Access Compliance Report

Public Rights-of-Way

| Intersection ID: 43498 | Main Street: DALTREY_LN | Cross Street: PRESCOTT_HILL_AV | Location: SW |
| ADA ID: 0431F4B352E1 | Ramp Type: PerpDiag | Initial Pass/Fail: Fail | Overall Compliance: No |

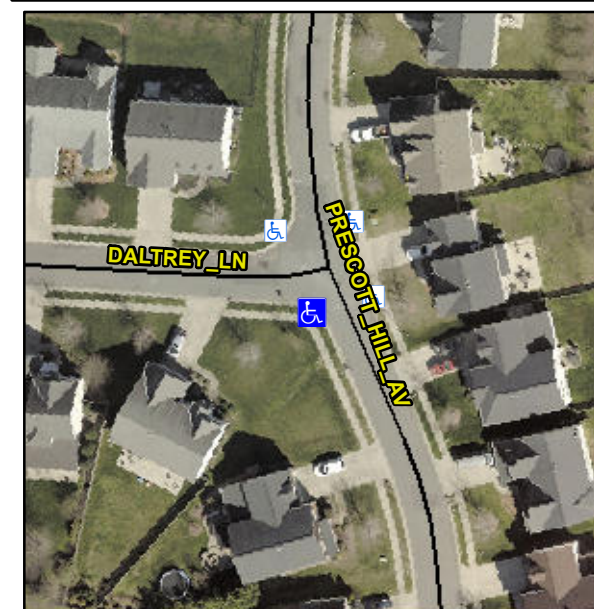
Not Found, R304.5.1, R304.2.2

| Compliance | Description | Data | Compliance | Description | Data |
|------------|-----------------------|------|------------|-----------------------------|------|
| N/A | Ramp Length (in) | 48.0 | No | Ramp Slope (%) | 8.6 |
| No | Ramp Width (in) | 38.0 | Yes | Ramp XSlope (%) | 1.4 |

Remove & Replace Curb Ramp With Two New Directional Ramps or Equivalent.
